MiTek Machinery SERVICE BULLETIN

Service Bulletin	SB128	Product	CTC Touch Screen
Date	04/23/02	Description	Updated Settings for UPDD driver
Revision Level

Purpose: Update UPDD driver settings for improved touch screen performance.

A. **Select** the **Settings** tab.

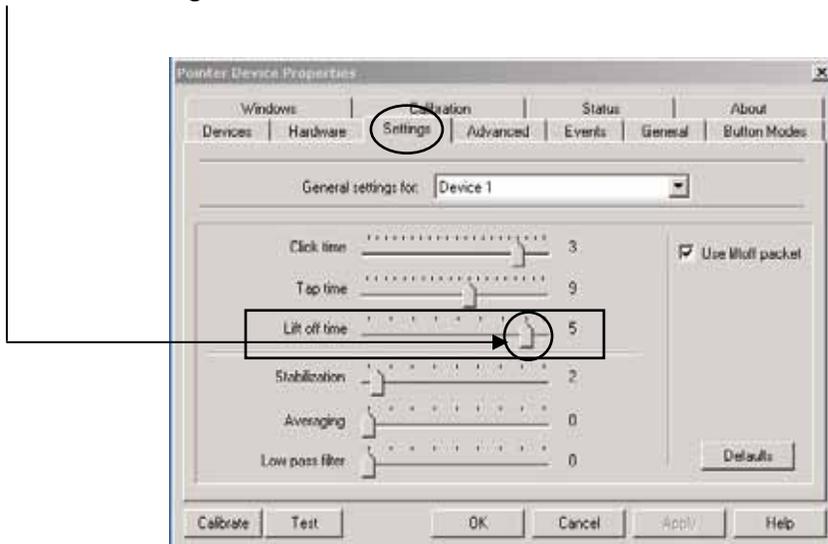
Now find the slider that says **Lift off time** and using your finger slide the marker to **5** as shown in the figure below.

B. **Select** the **Advanced** tab

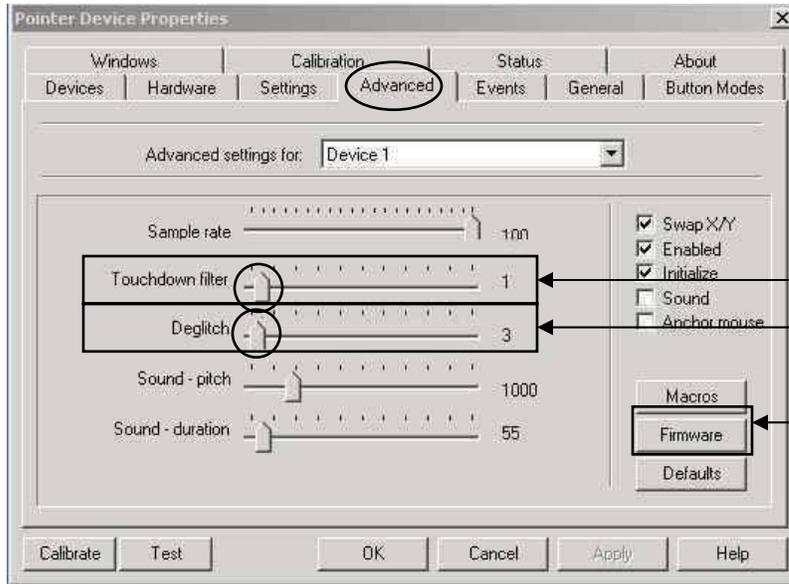
For the **Touchdown filter** setting, **slide** the marker so that the value is **1**

For the **Deglitch** setting, **slide** the marker so that the value is **3**

C. Firmware Setting

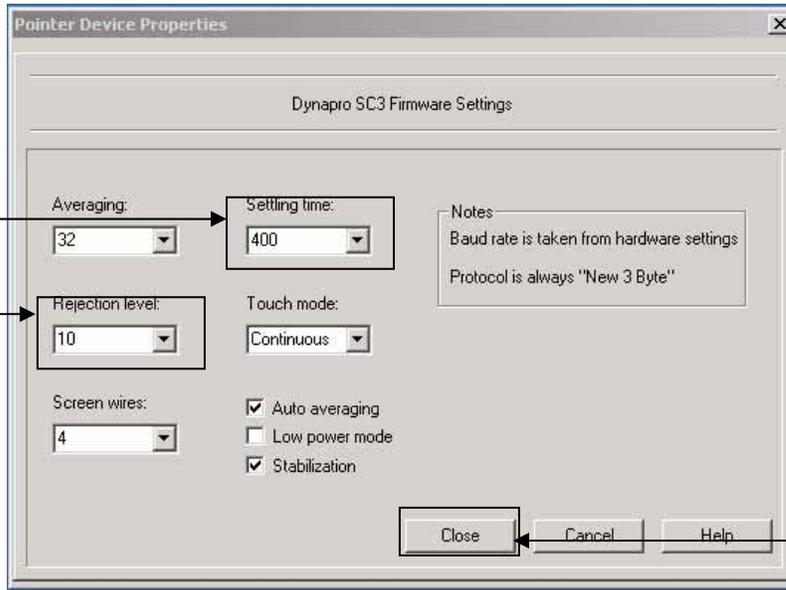
For **Rejection level, press** the ▾ arrow to highlight the option and select the value **10** from the list**.**

For **Settling time, press** the ▾ arrow to highlight the option and select the value **400** from the list.

D. **Select** the **Windows** tab and verify that the **Time** setting is set to **500**

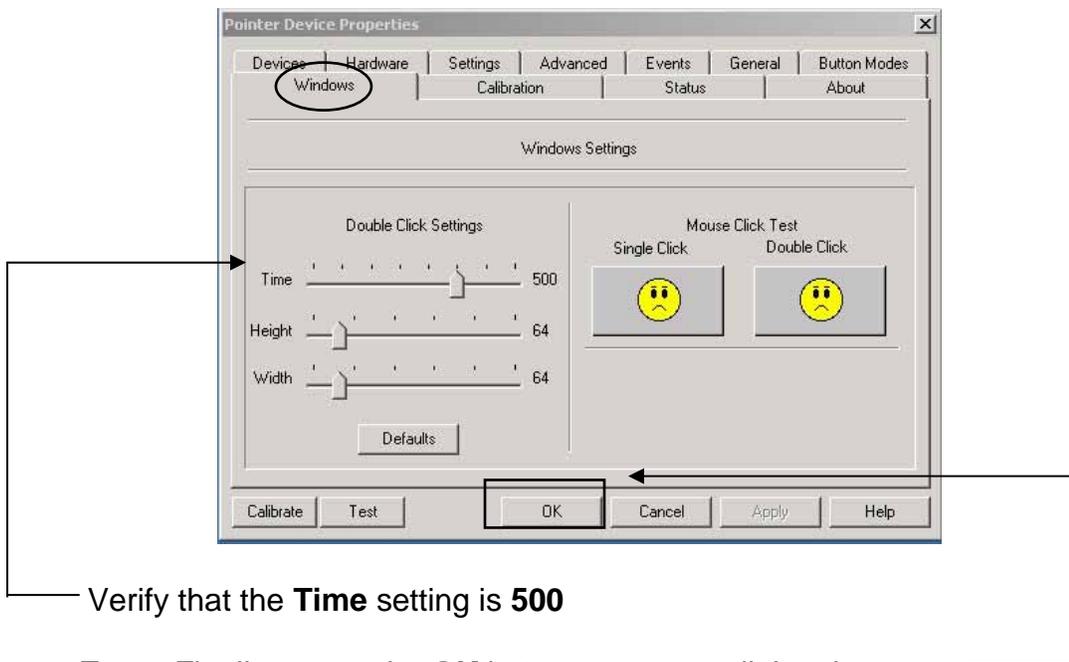
Verify that the **Time** setting is **500**
